# UNITED STATES PATENT AND TRADEMARK OFFICE

APPLICATION NO.	FILING DATE	FIRST NAMED INVENTOR	ATTORNEY DOCKET NO.	CONFIRMATION NO.
10/585,162	06/30/2006	Stefan Morgenstern	5038.1030	8326
23280	7590	10/07/2009	EXAMINER	
Davidson, Davidson & Kappel, LLC 485 7th Avenue 14th Floor New York, NY 10018		PRAGER, JESSE M		
		ART UNIT		PAPER NUMBER
		3745		
		MAIL DATE		DELIVERY MODE
		10/07/2009		PAPER

<b>Office Action Summary</b>	<b>Application No.</b>	<b>Applicant(s)</b>	
	10/585,162	MORGENSTERN ET AL.	
	<b>Examiner</b>	<b>Art Unit</b>	
	JESSE PRAGER	3745

Fig.3.

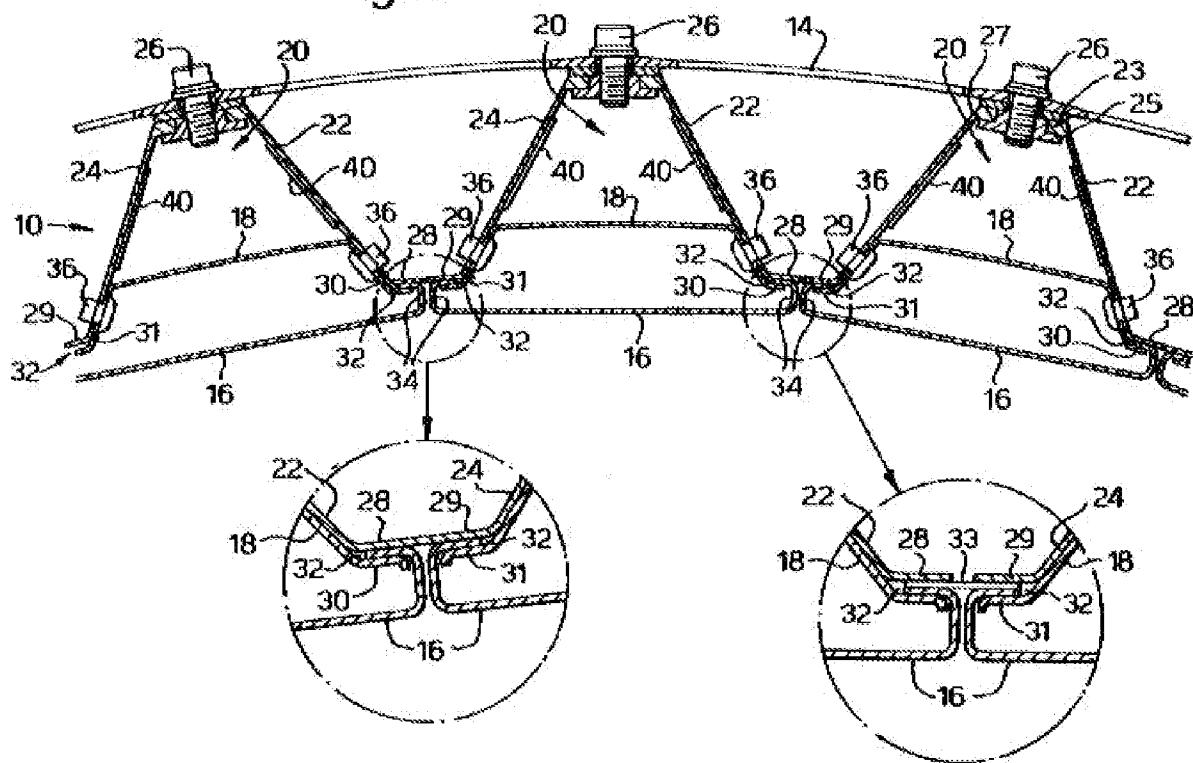
Applicant argues that the Hayton reference lacks “each web-like element ... forming a crenelated profile extending in a circumferential direction of the housing”, and includes Fig. 4 to show a crenelated profile extending in the axial direction.

Examiner respectfully disagrees with the statement “the alleged web-element (22, 24) is not crenelated in the circumferential direction”. As stated in the office action, “web elements (22, 24) extend to the first and second plate elements forming a crenelated profile extending in a circumferential direction of the housing.” Figure 3 is a cross sectional view showing that the web-elements are crenelated in the circumferential direction.

The crenelated profile is formed by first plate 29 (left) to web element 24, to first plate 23, to web element 22, to second plate elements (28, 29) to web element 24, to first plate 23 to web element 22 to first plate 28. The indented and notched structure makes the profile crenelated in the circumferential direction, and the rejection of claim 11 is maintained since the applicant has not overcome the prima facie case of obviousness.
